VIRGINIA ELECTRIC AND POWER COMPANY
RICHMOND, VIRGINIA 23261

January 26, 1993

VIRGINIA ELECTRIC AND POWER COMPANY
SURRY POWER STATION UNITS 1 AND 2
SECOND TEN YEAR INSERVICE INSPECTION INTERVAL
RELIEF REQUESTS

**Surry Units 1 and 2
ISI Relief Requests**

**INSERVICE INSPECTION DETAIL DRAWING
REACTOR COOLANT PUMP: 2-RC-P-1A
SURRY POWER STATION UNIT 2
VIRGINIA POWER**

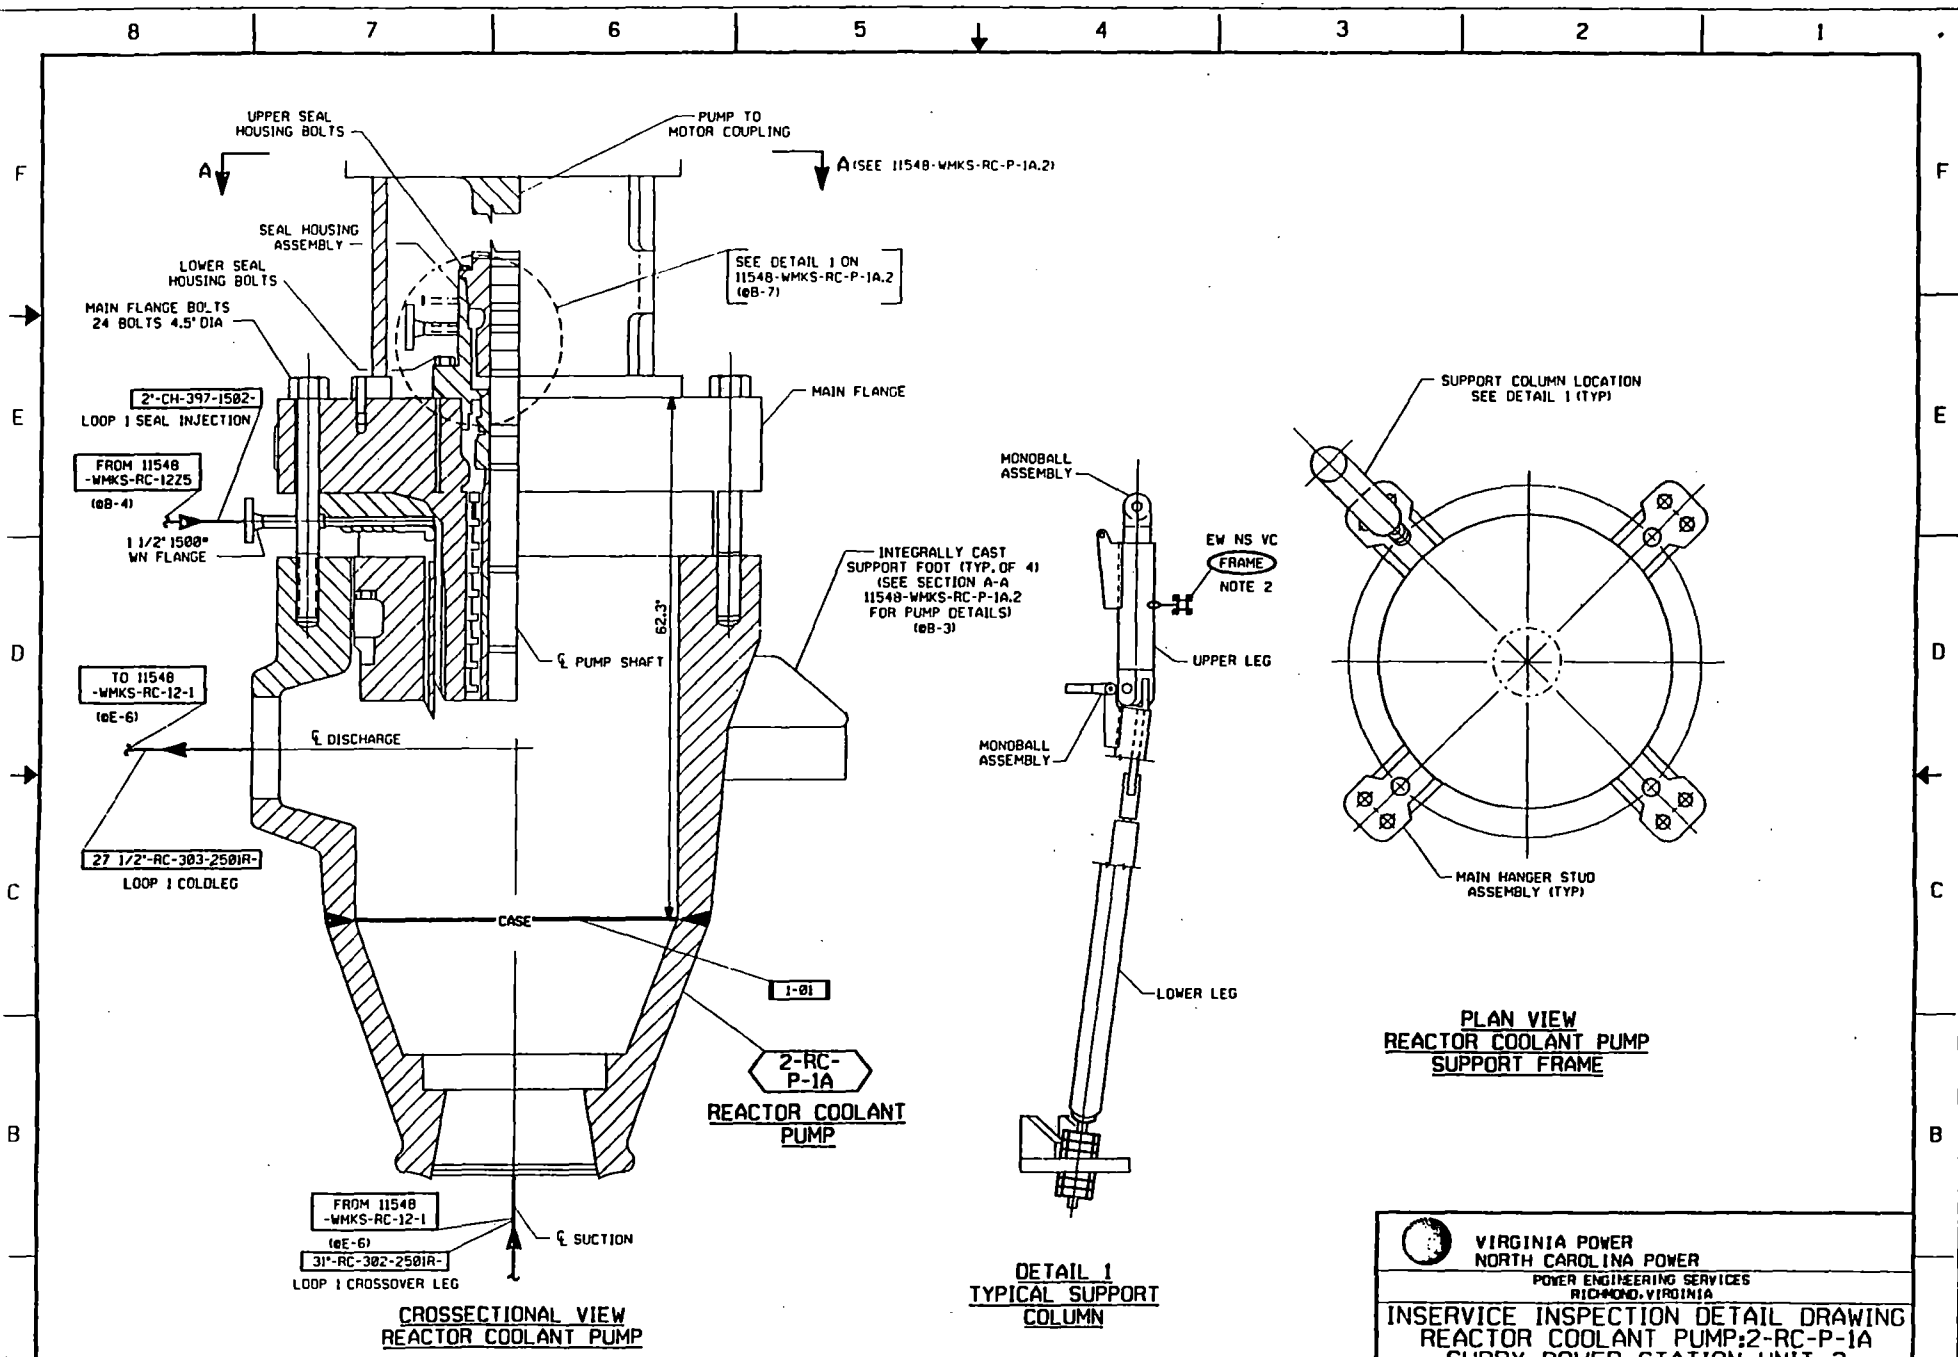
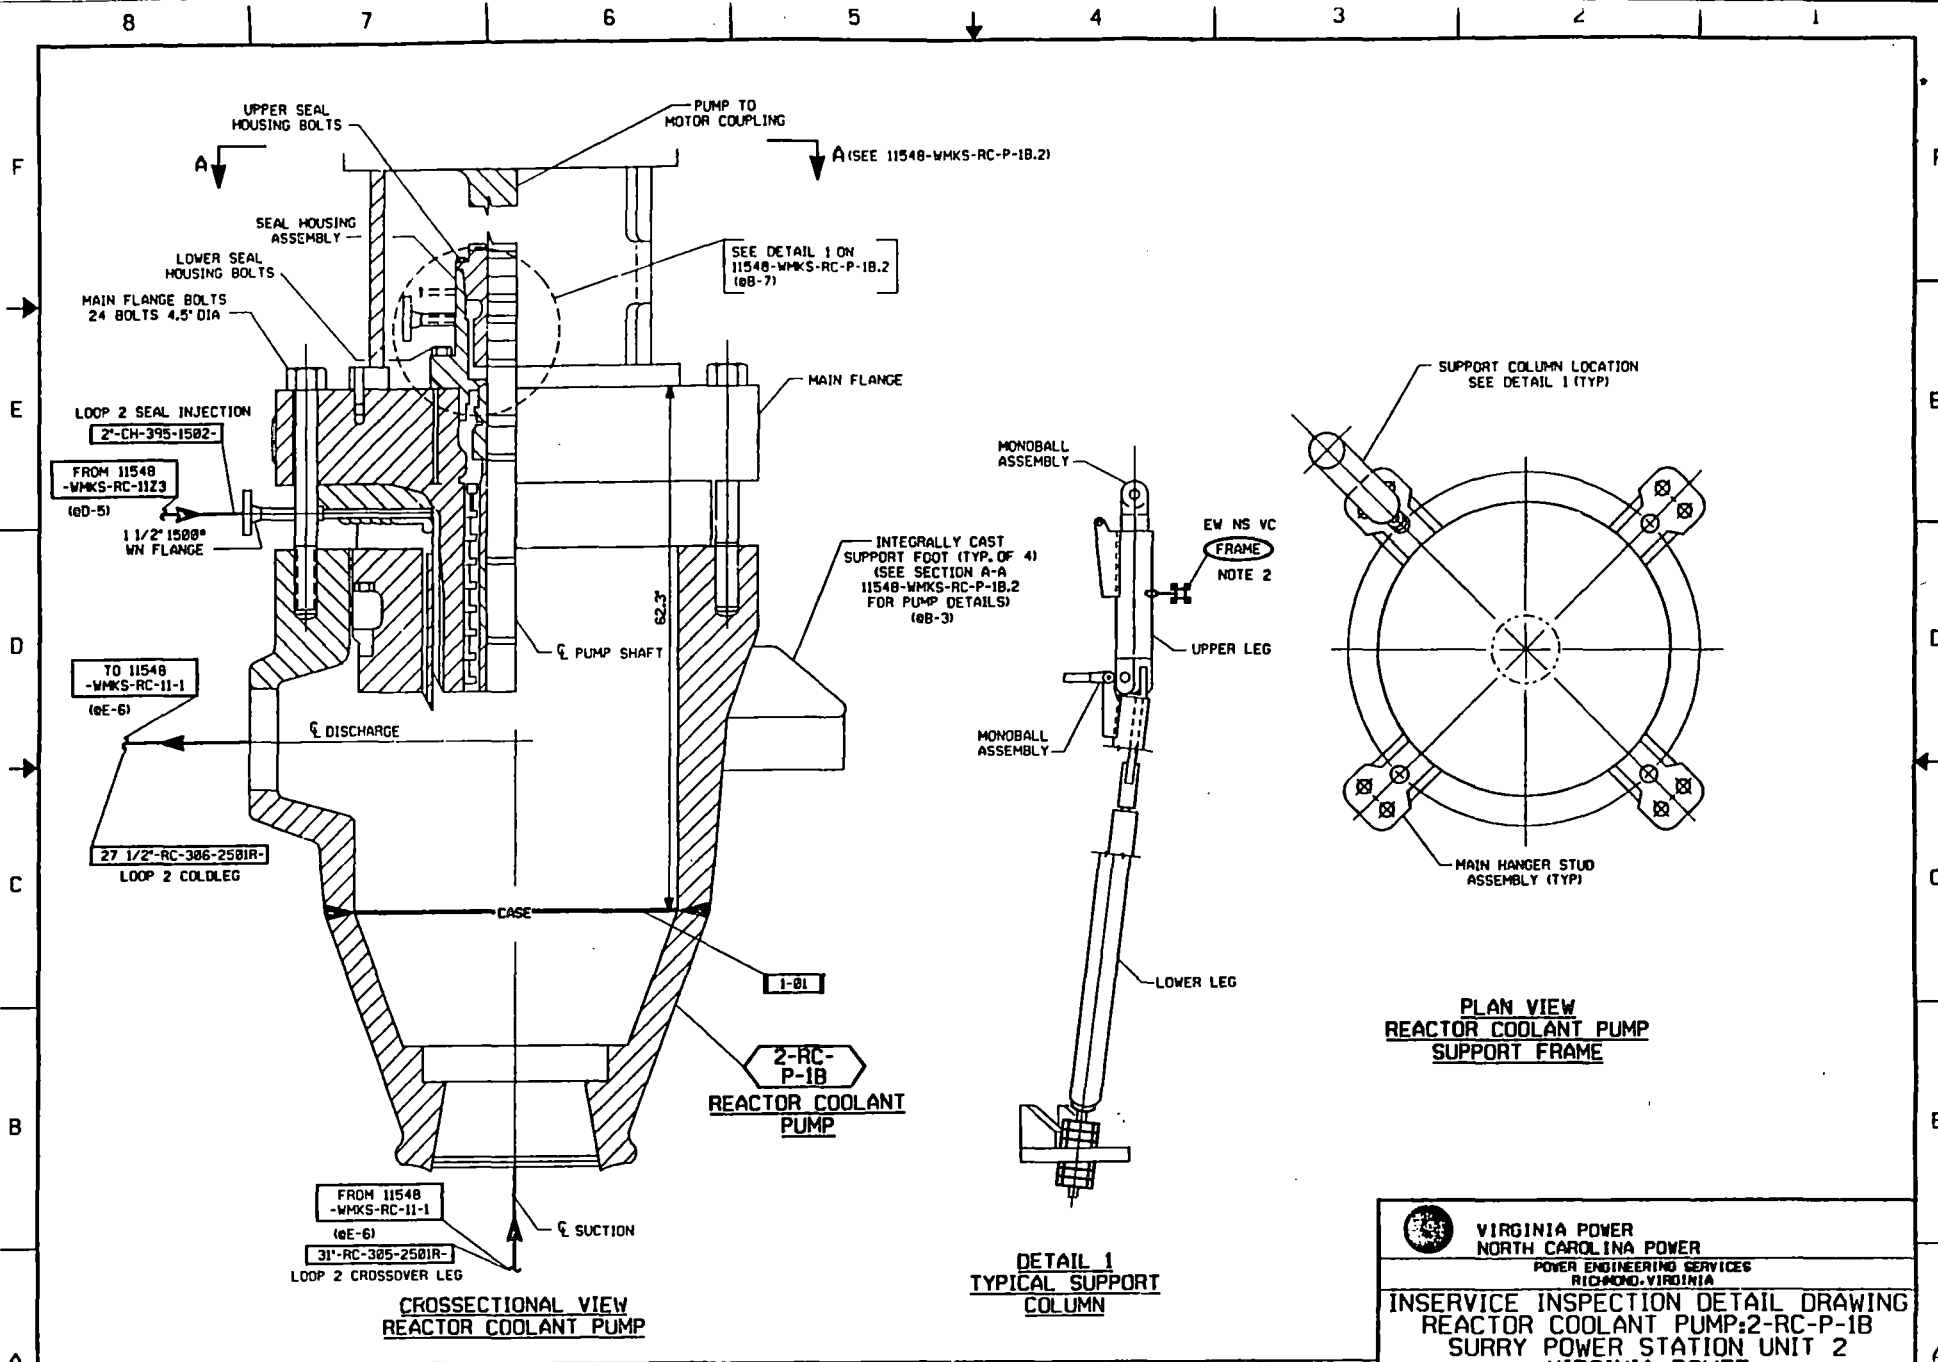
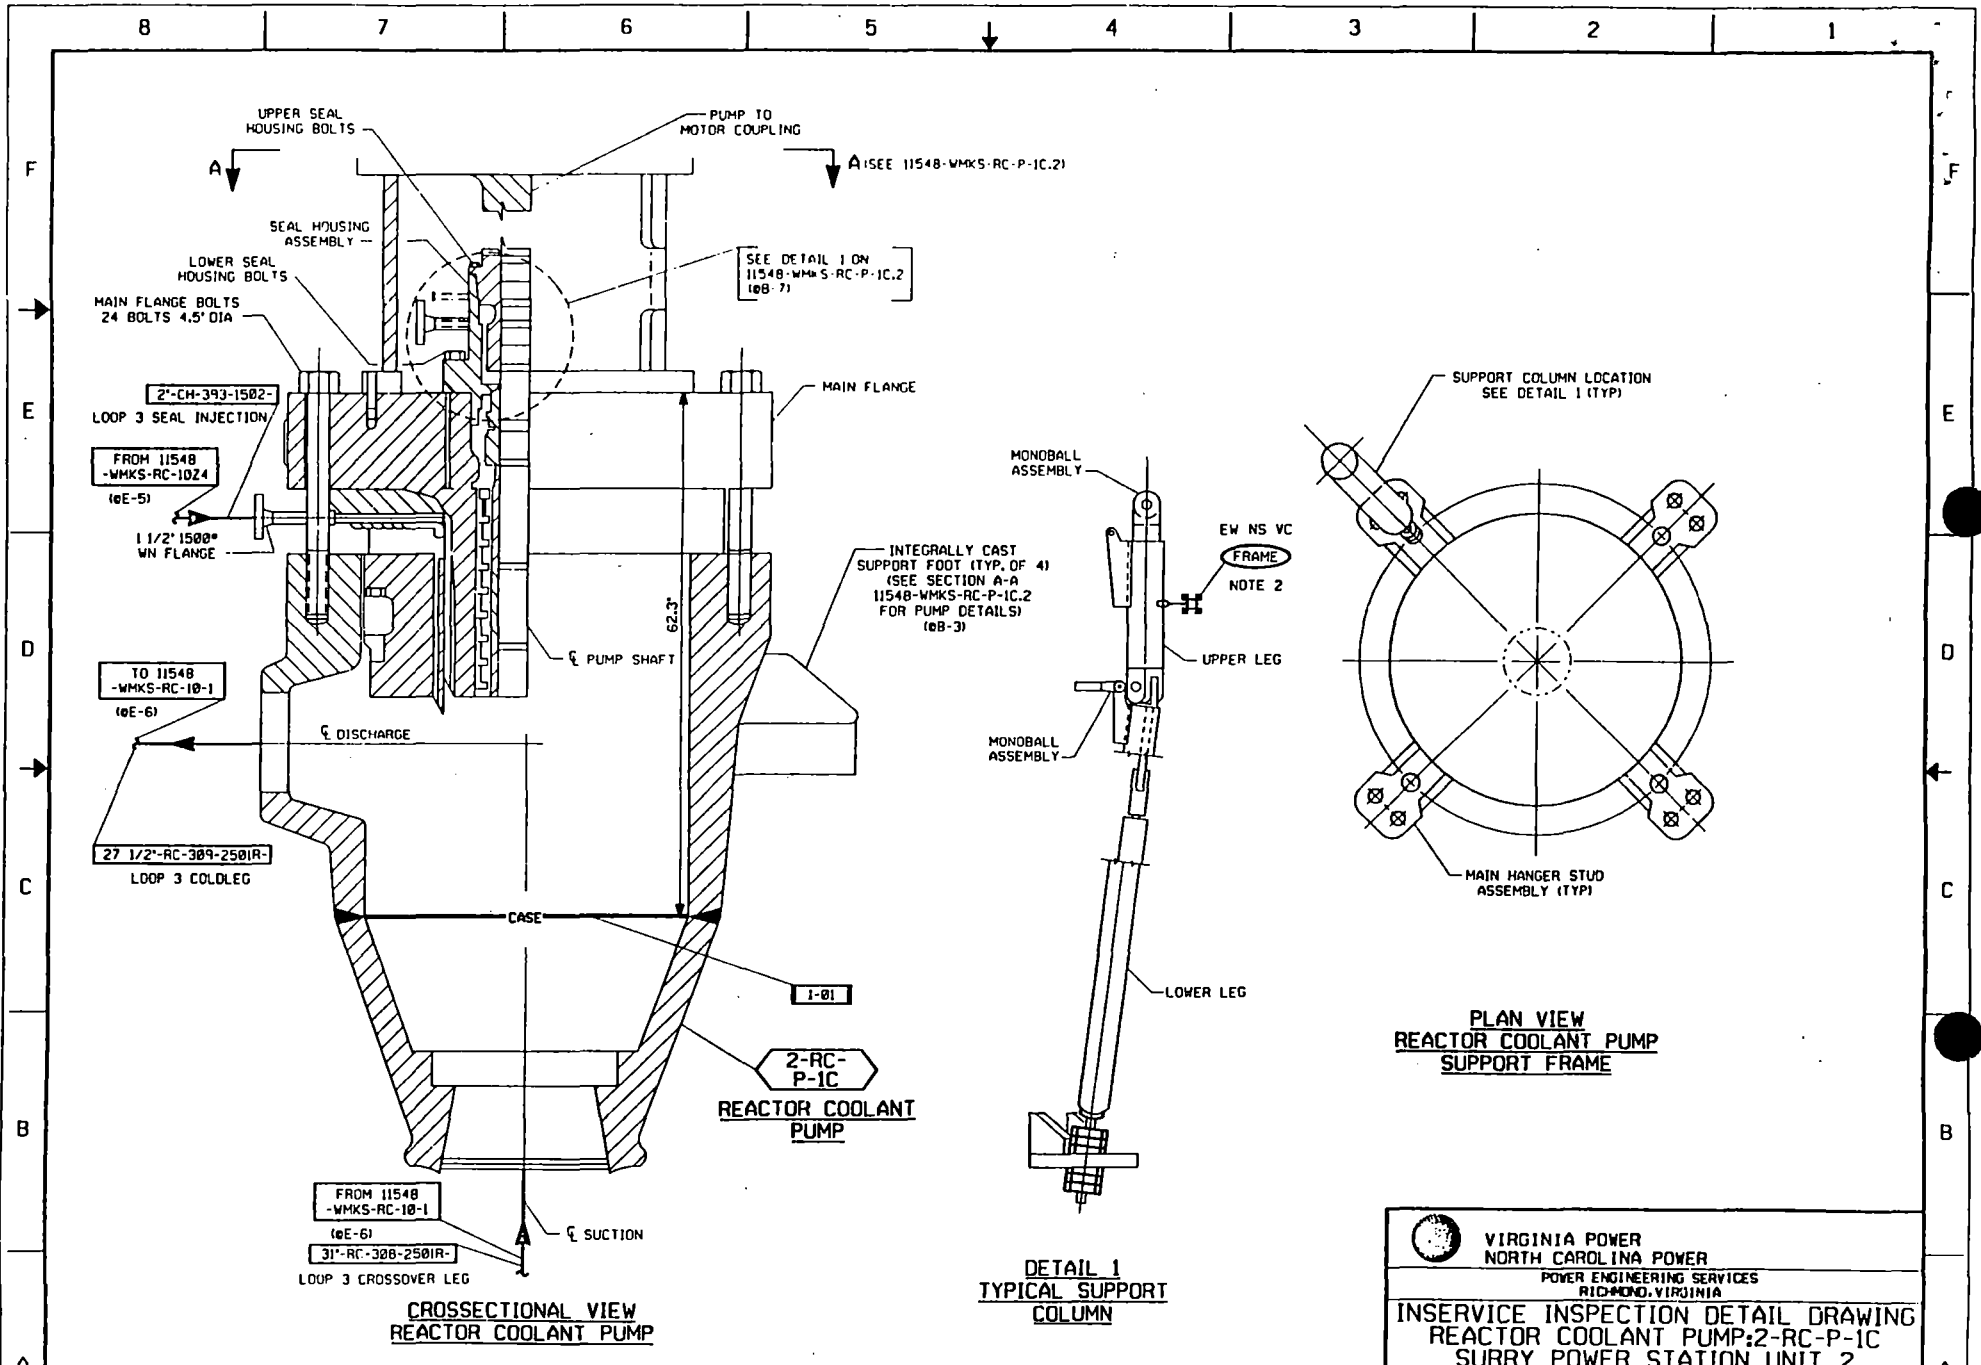
Category B-L-2, Pump Casings, Item number B12.20 requires a visual, VT-3, examination be conducted on the pump casing internal surfaces of one pump performing similar functions.

Performance of the Code required visual examination requires that the pump be disassembled to allow access to the pumps internal surfaces. Previously this examination was scheduled in conjunction with the Code required volumetric examination on the pump casing weld, which also required pump disassembly. Code Case N-481, Alternate Examination Requirements for Cast Austenitic Pump Casings Section XI, Division 1, will be used in lieu of the volumetric examination required by Table IWB 2500-1, Category B-L-1, Item B12.10. Requiring pump disassembly for the Code visual examination is impractical considering the cost and dose required to perform this action.
